Our Ref: 20227

**RE: MEDI-HOTEL DEVELOPMENT 28-32 SOMERSET STREET KINGSWOOD
DA22/0326 RESPONSE TO ISSUES – TRAFFIC**

Attachment – Car Park Review (File 20227CAD022-220328-CAR PARK REVIEW-13.pdf)

PROJECT	28-32 SOMERSET STREET, KINGSWOOD		
TITLE	CAR PARK COMPLIANCE REVIEW BASEMENT LEVEL 2

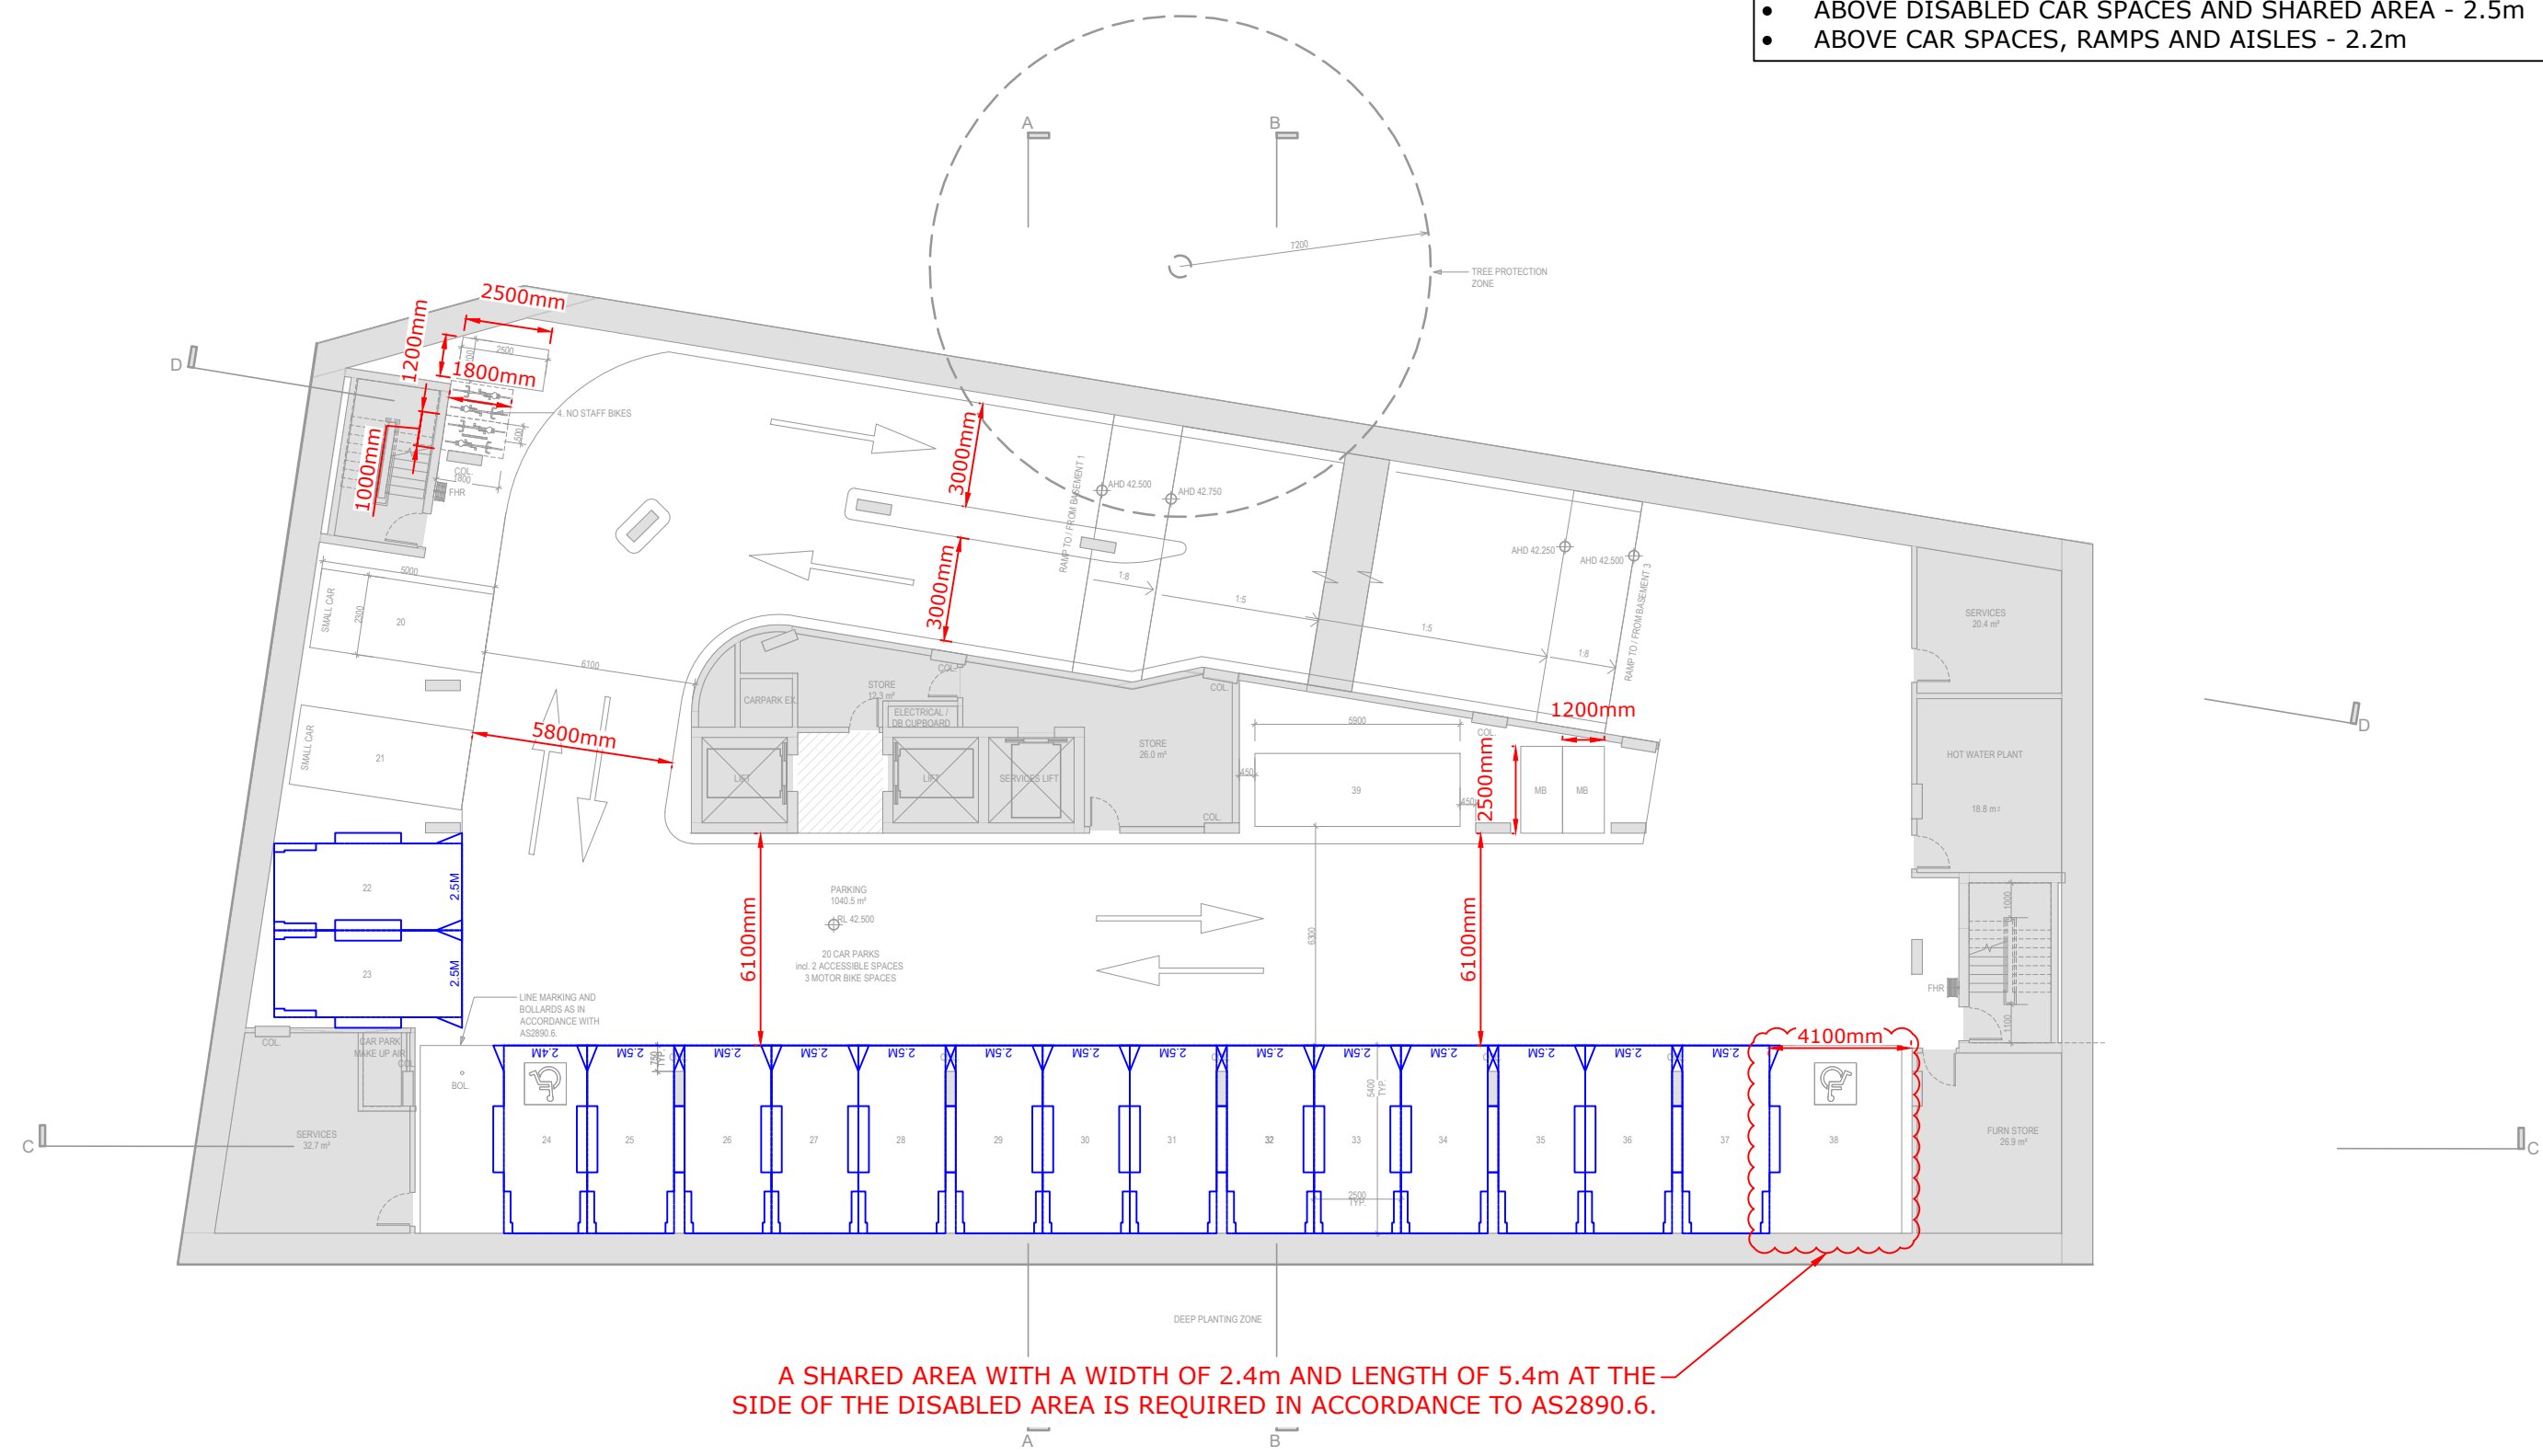
A SHARED AREA WITH A WIDTH OF 2.4m AND LENGTH OF 5.4m AT THE SIDE OF THE DISABLED AREA IS REQUIRED IN ACCORDANCE TO AS2890.6.

TITLE
**CAR PARK COMPLIANCE REVIEW
 BASEMENT LEVEL 3**

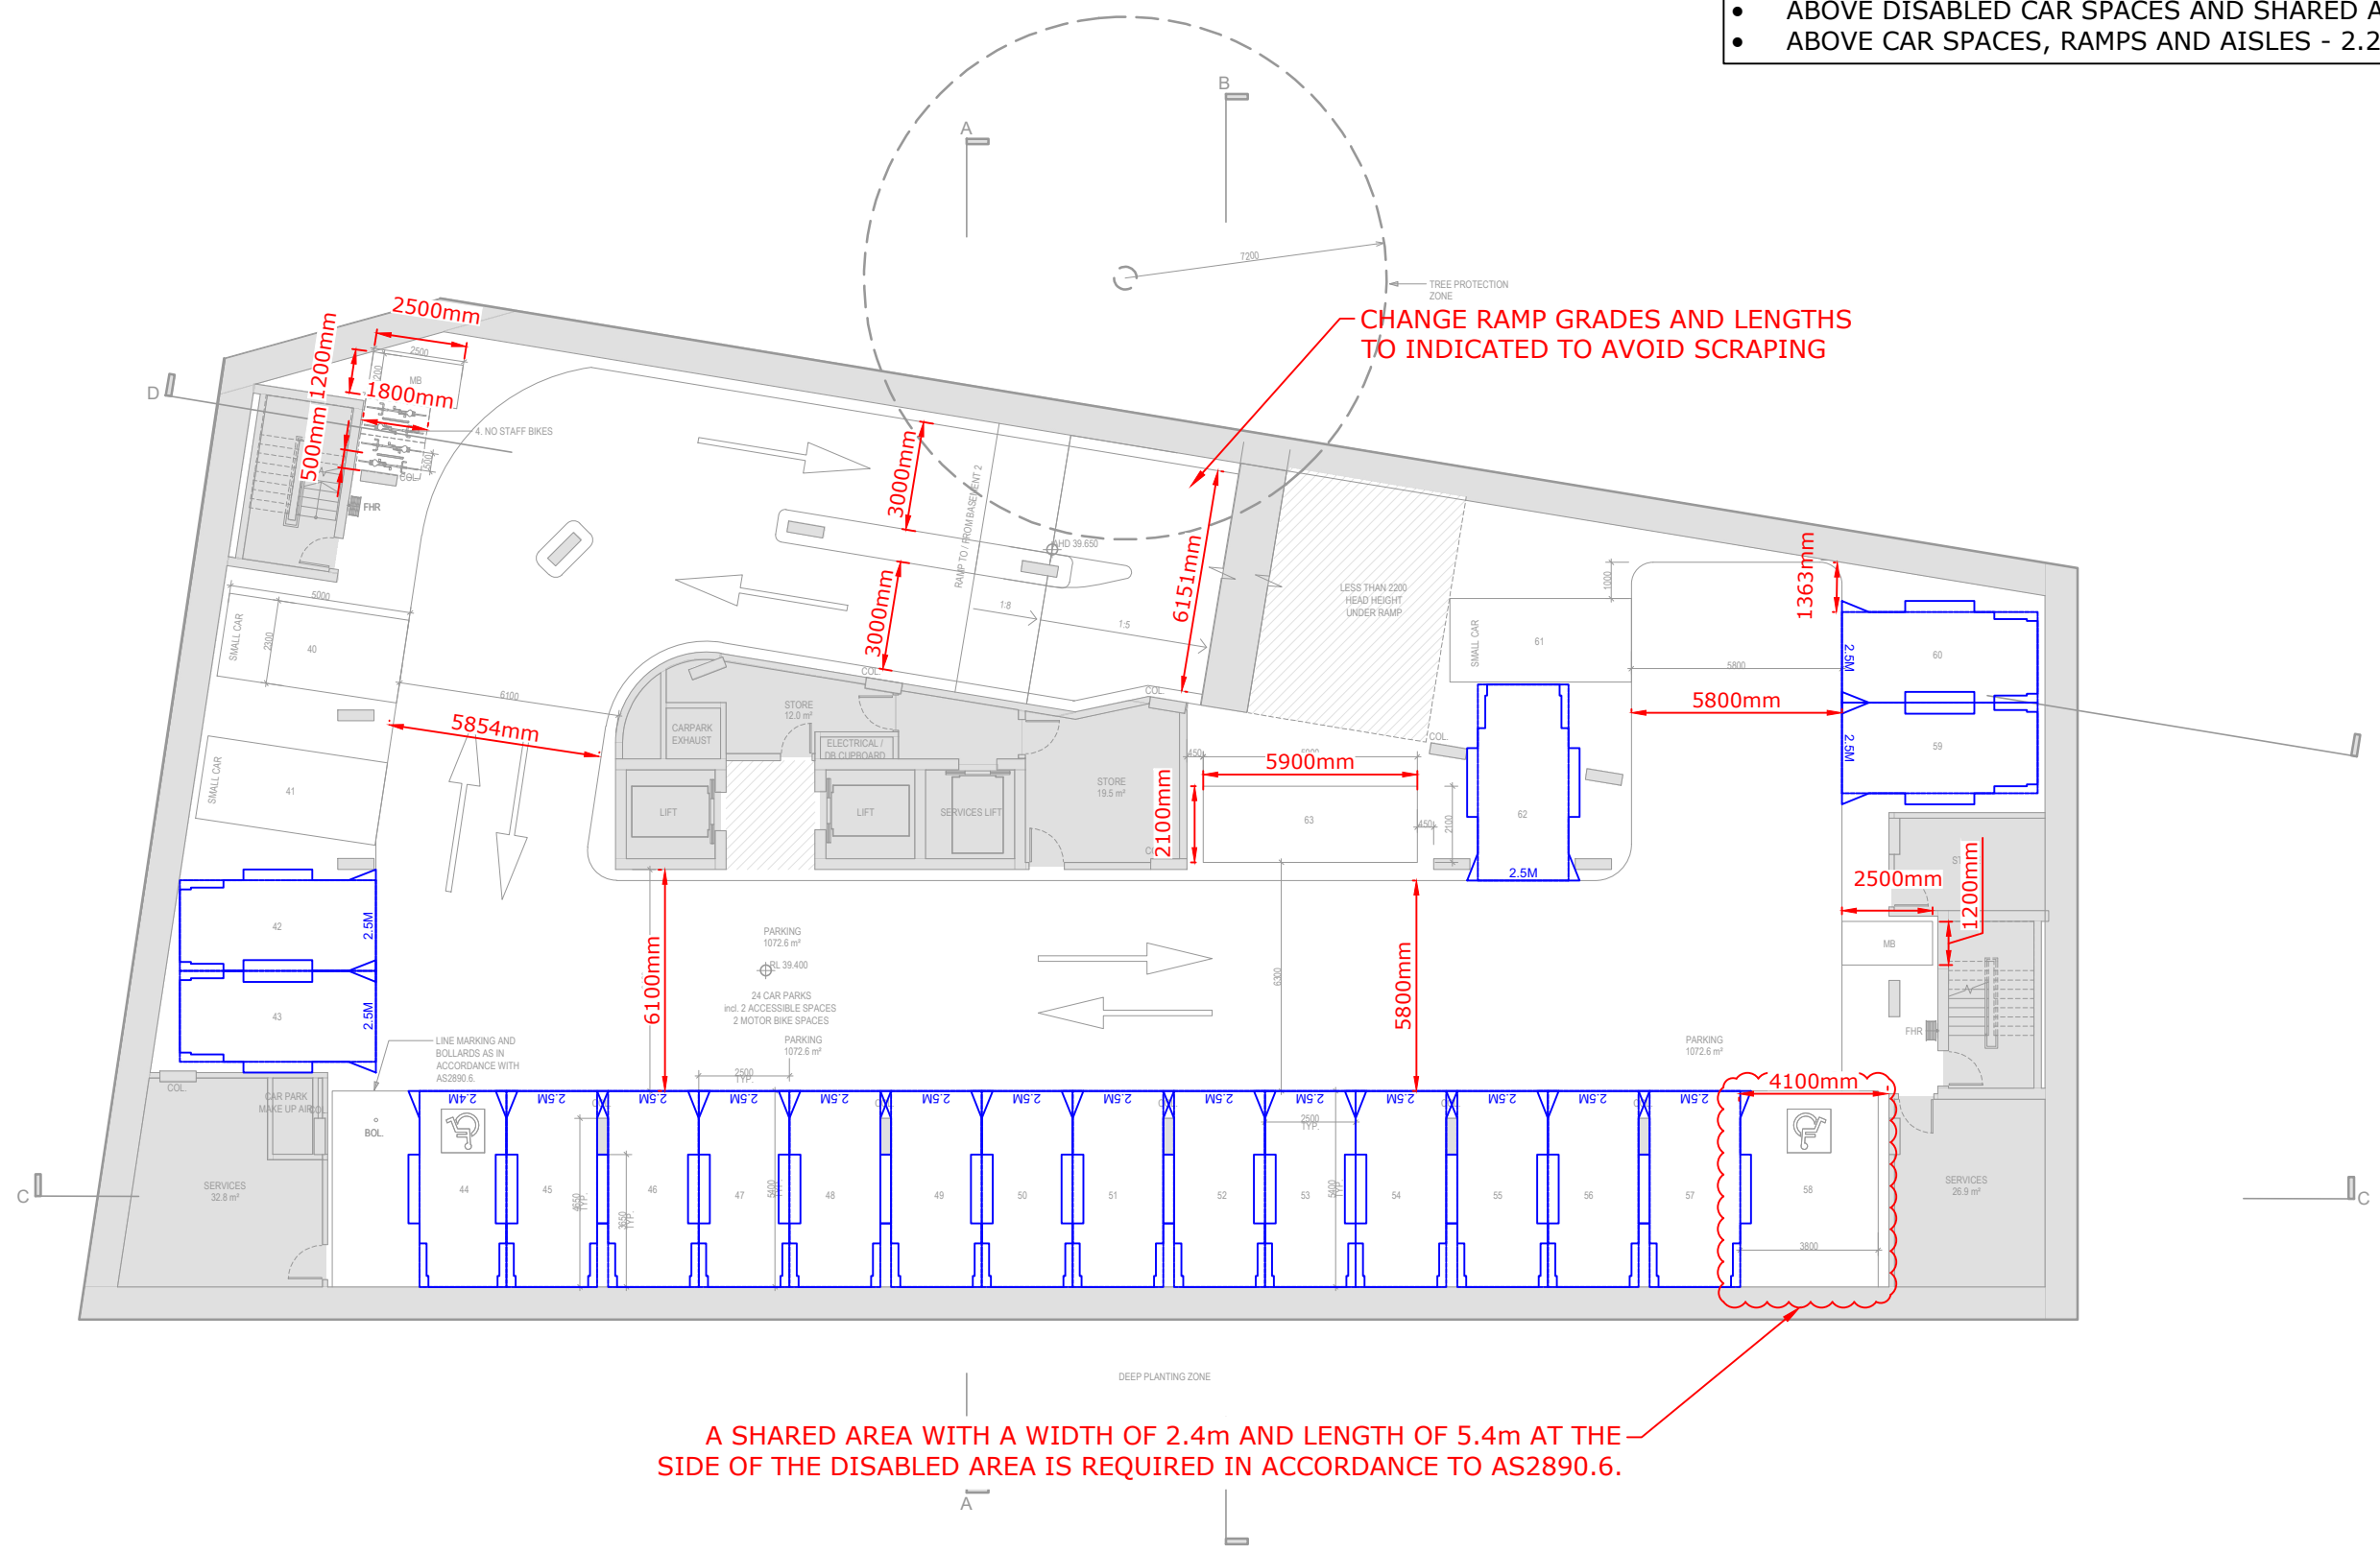
A SHARED AREA WITH A WIDTH OF 2.4m AND LENGTH OF 5.4m AT THE SIDE OF THE DISABLED AREA IS REQUIRED IN ACCORDANCE TO AS2890.6.
